SYMBOL	DESCRIPTION	DATE	APPR.
REVISIONS			
OFFICE OF CARL R. BLANCHARD JR. ARCHITECTS	DEPT. OF THE NAVY BUREAU OF YARDS & DOCKS		
NEW HAVEN, CONNECTICUT	DISTRICT PUBLIC WORKS OFFICE		
	THIRD NAVAL DISTRICT		
	U.S. NAVAL SUBMARINE BASE - NEW LONDON - GROTON, CONNECTICUT		
CHapel & Religious Education Building			
PLOT PLAN, LOCATION MAP & TEST BORING DATA			
DESIGNED BY [Signature]	DATE [Date]	CODE IDENT NO	SIZE
DRAWN BY [Signature]	DATE [Date]	1082655	33" x 42"
APPROVED [Signature]	DATE [Date]	NBY 63823	
OFFICER IN CHARGE	DATE [Date]	SCALE AS NOTED	SPEC 63823/65
APPR. FOR BLDG. OFFICE	DATE [Date]		
APPR. FOR CHIEF OF BUREAU	DATE [Date]

SYMBOL	DESCRIPTION	DATE	APPR
△	DRIVE, PARKING AREA & GRADING MODIFIED; WALKWAY FEEL LANE ELIMINATED.	6/9/68	
△	REV LAYOUT OF DRIVE & DRAINAGE	4/5/68	
REVISIONS			
OFFICE OF CARL R. BLANCHARD JR. ARCHITECTS NEW HAVEN, CONNECTICUT		DEPT. OF THE NAVY THIRD NAVAL DISTRICT NEW YORK, N.Y.	
DES. WD. DR. RG. CHK. WD. SUPV. CC. CH. ENGR. CC.		BUREAU OF YARDS & DOCKS DISTRICT PUBLIC WORKS OFFICE NEW YORK, N.Y.	
U.S. NAVAL SUBMARINE BASE - NEW LONDON - GROTON, CONNECTICUT			
CHAPEL & RELIGIOUS EDUCATION BUILDING			
PLOT PLAN			
APPROVED	DATE	CODE IDENT NO.	SIZE

**WATER METER PIT AND PIPING DETAIL**  
 NO SCALE

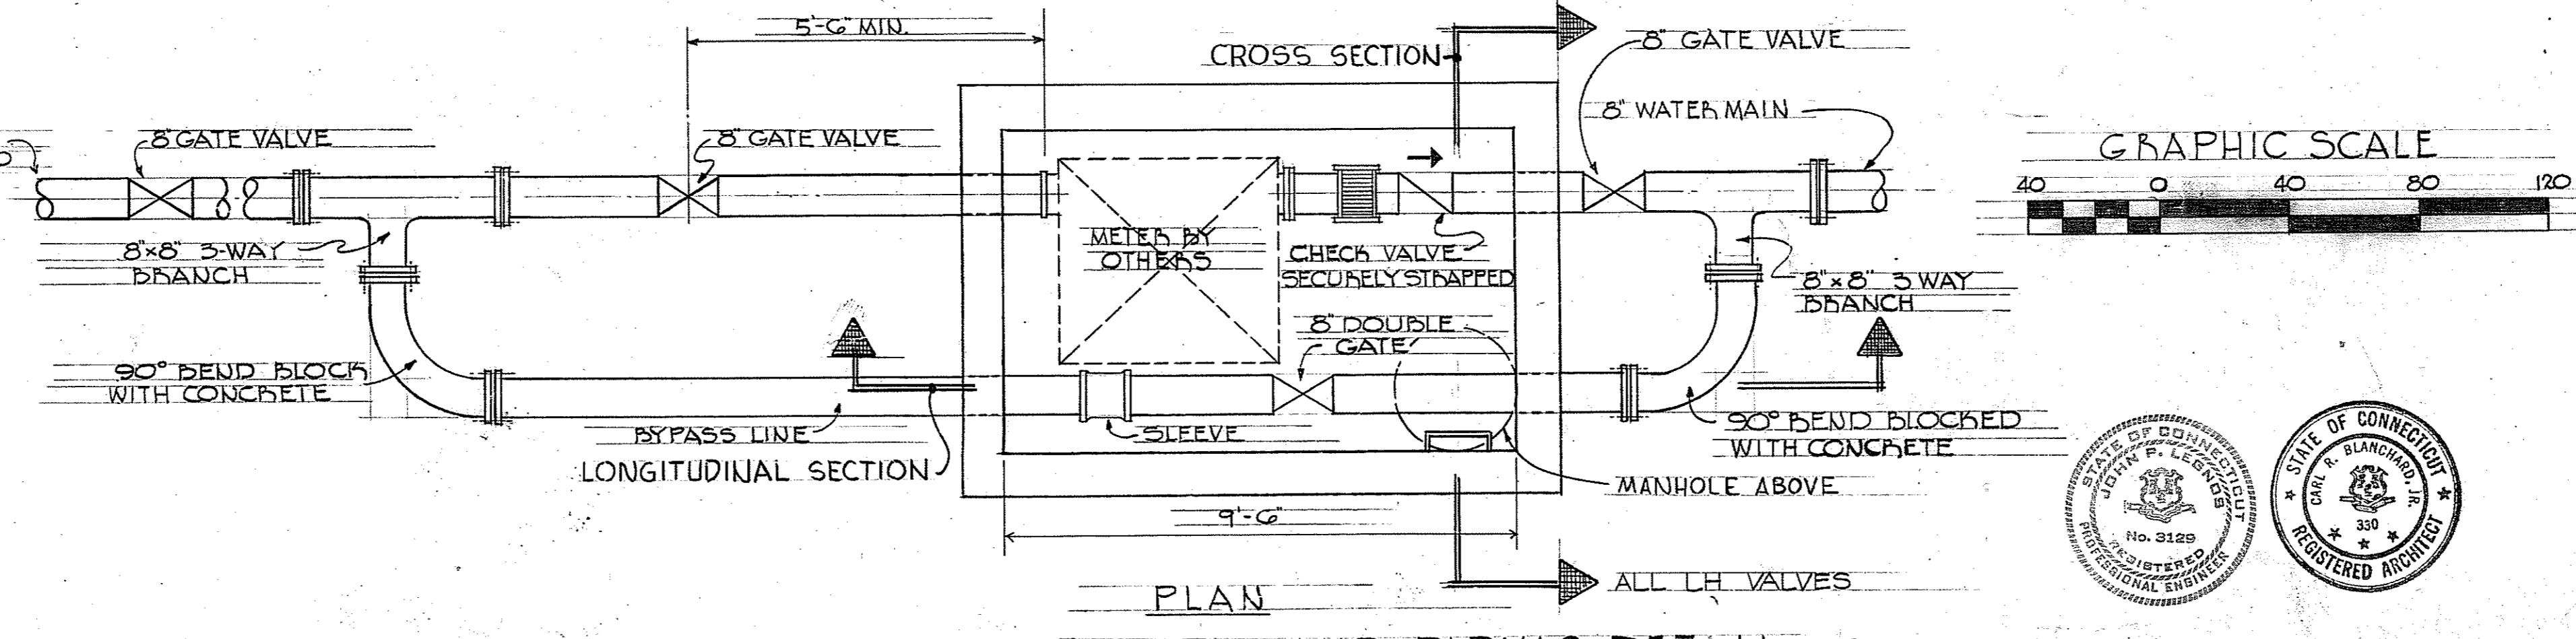
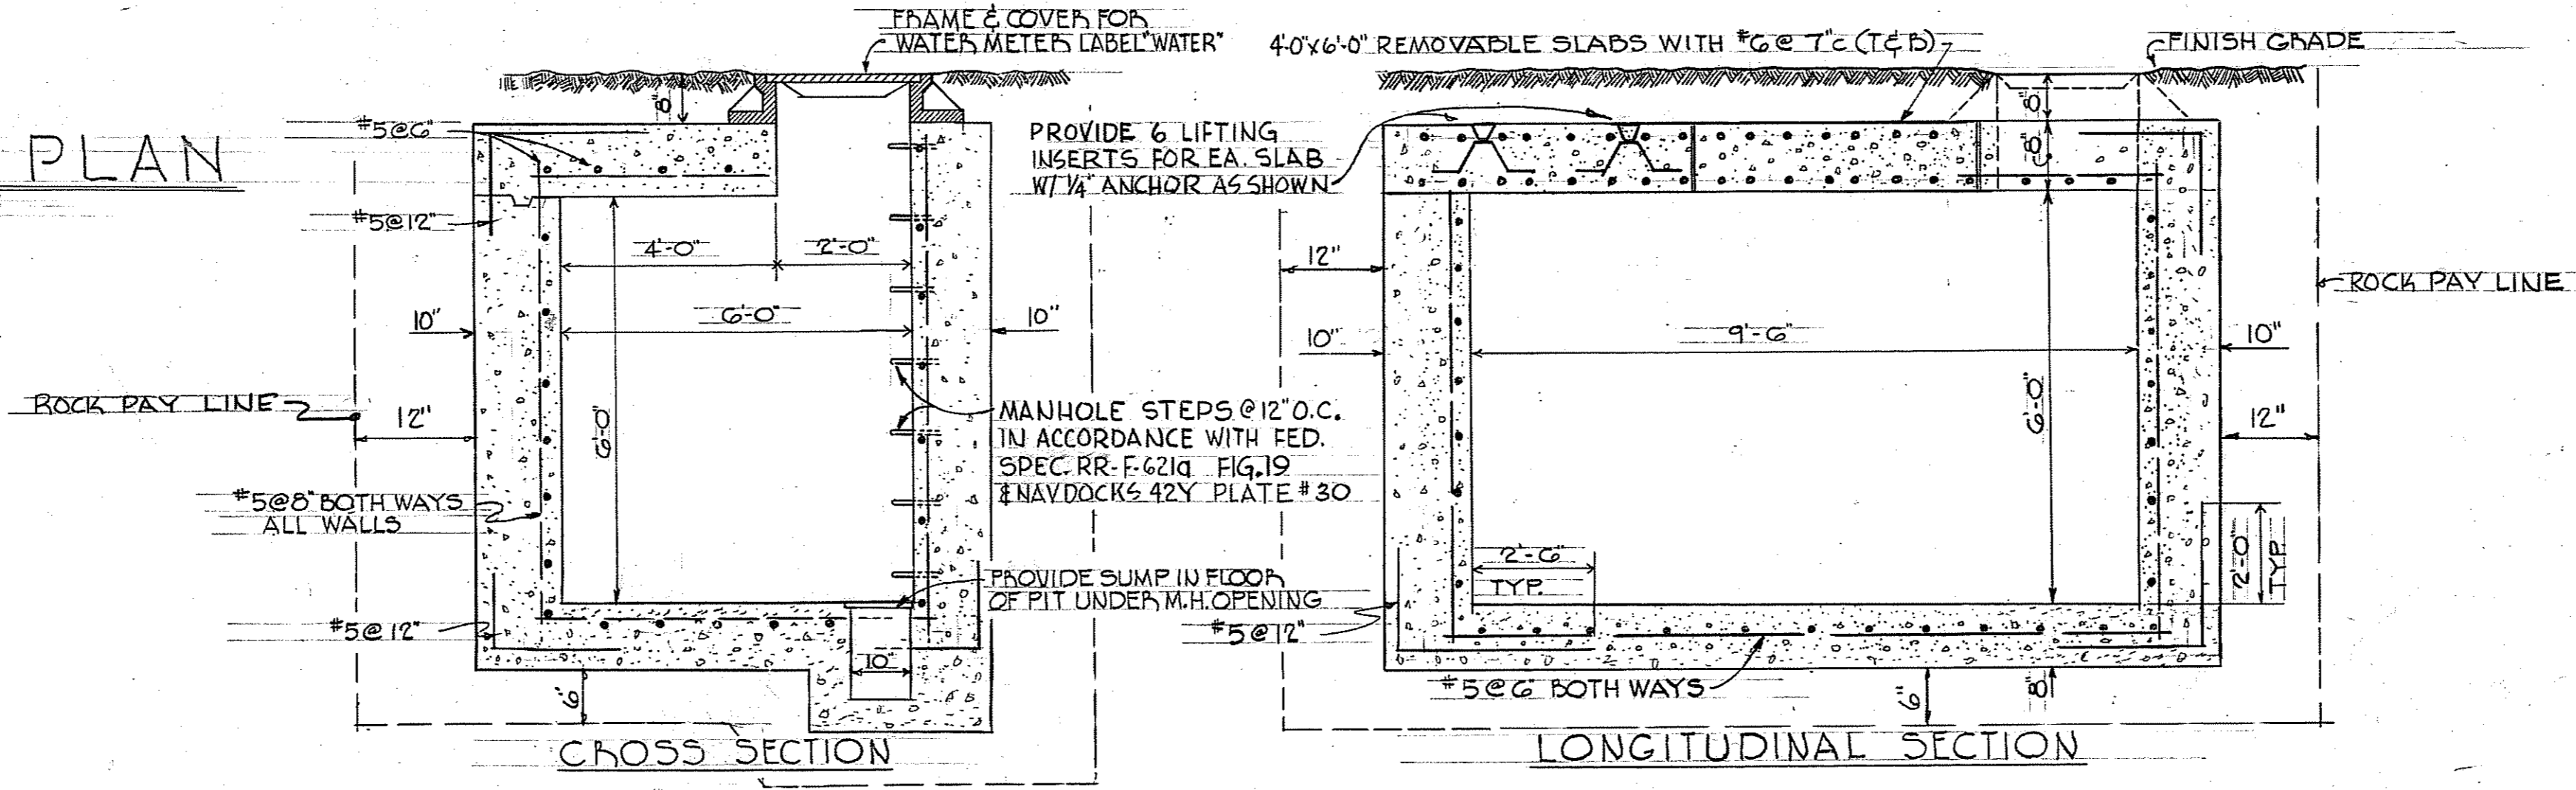
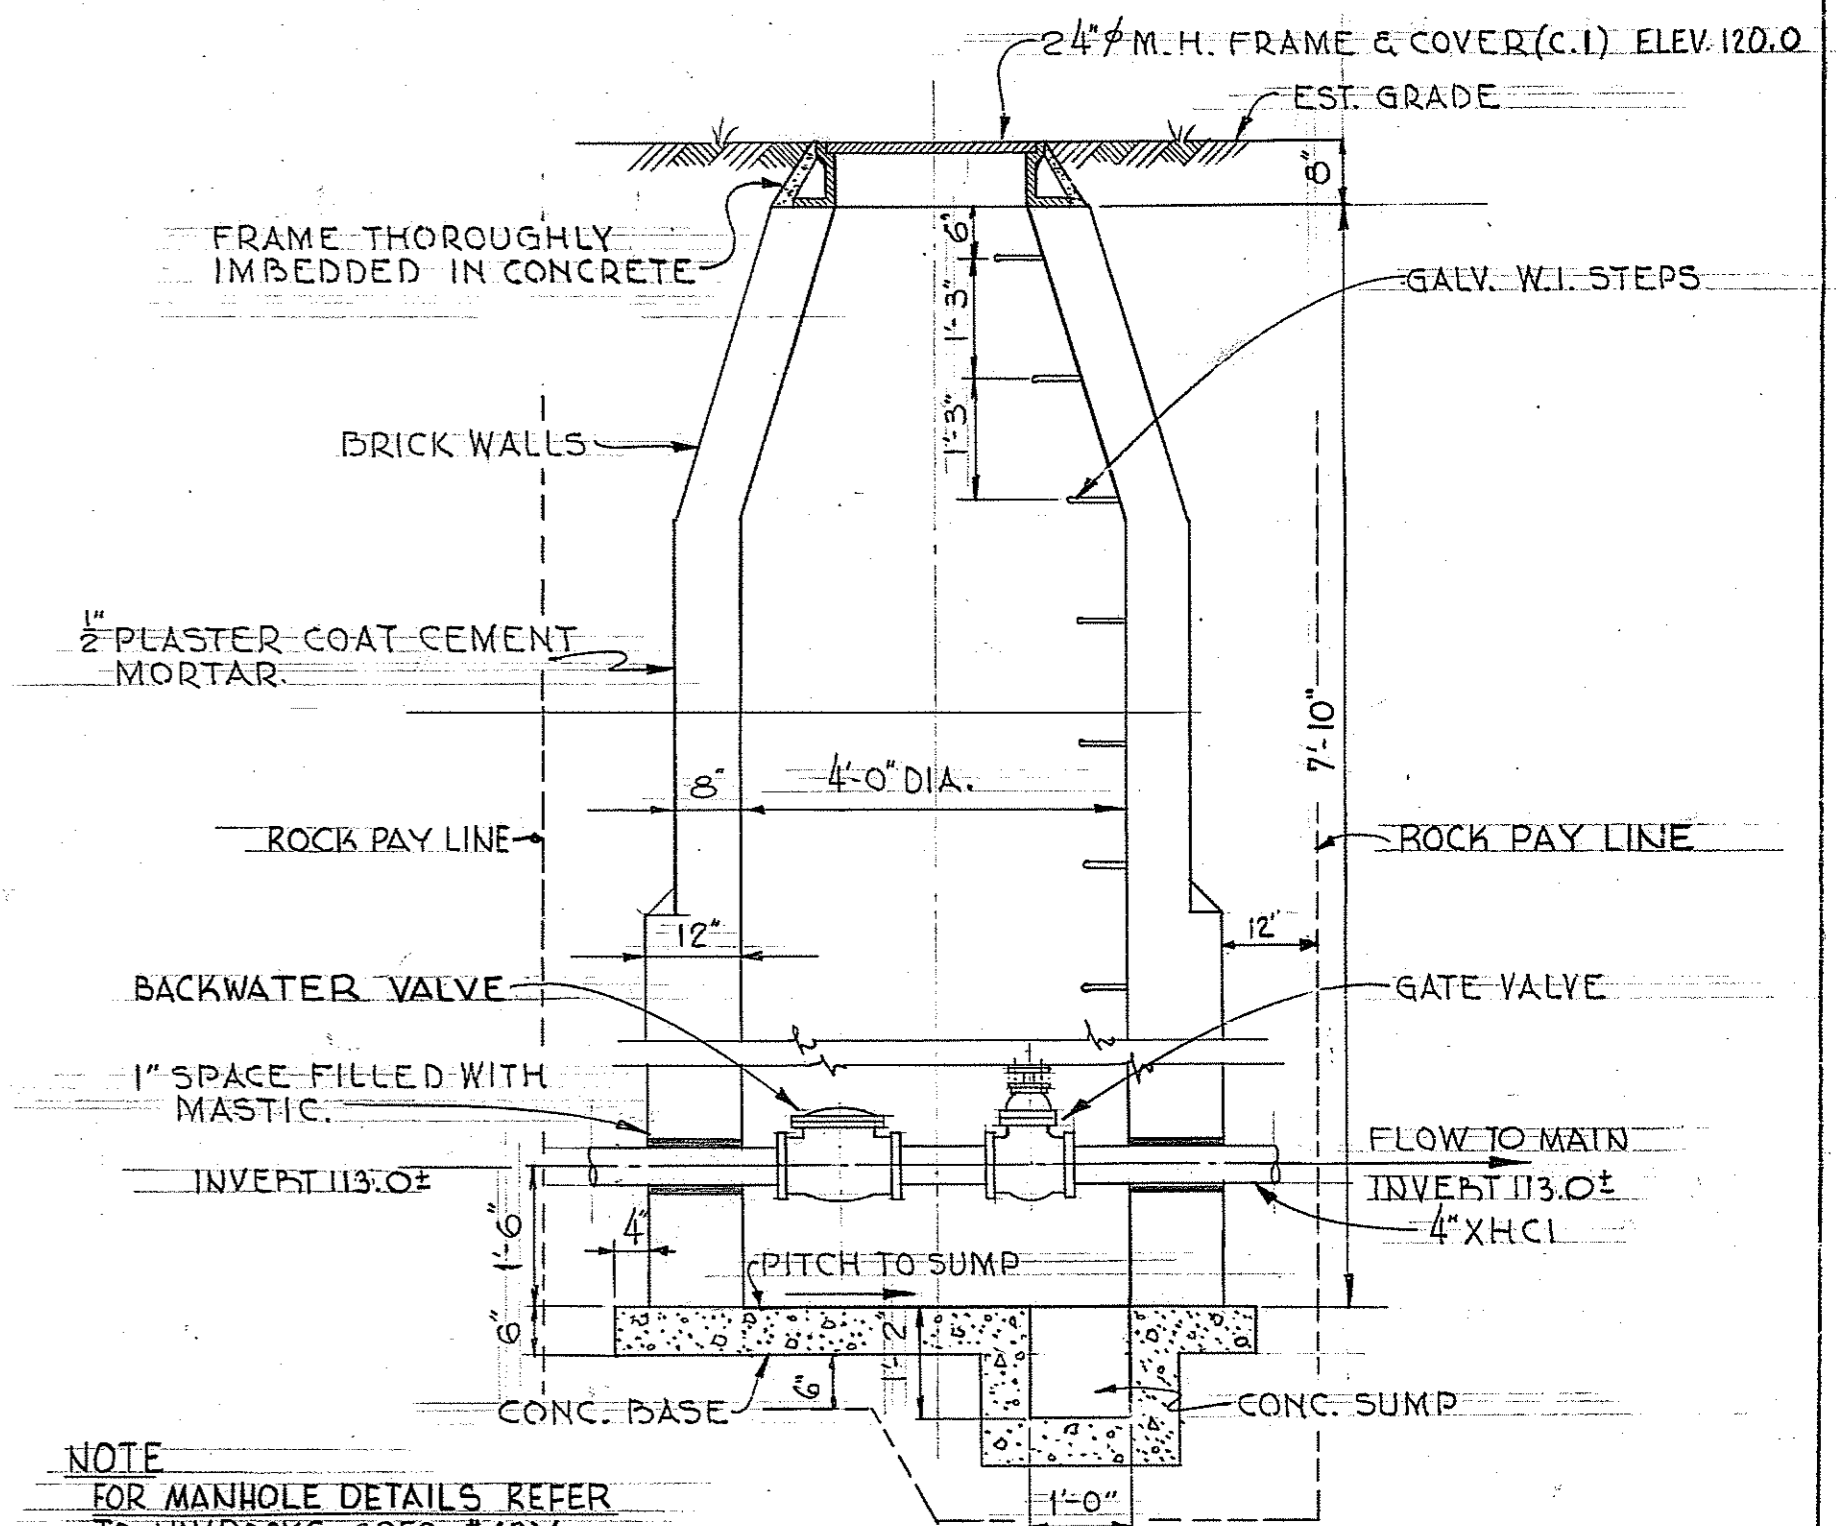
**NOTE ON CHANGES**  
 1. NOTE LH VALVES IN WATER METER PIT AND PIPING DETAIL.  
 2. MOVE WATER METER PIT IN SITE PLAN.
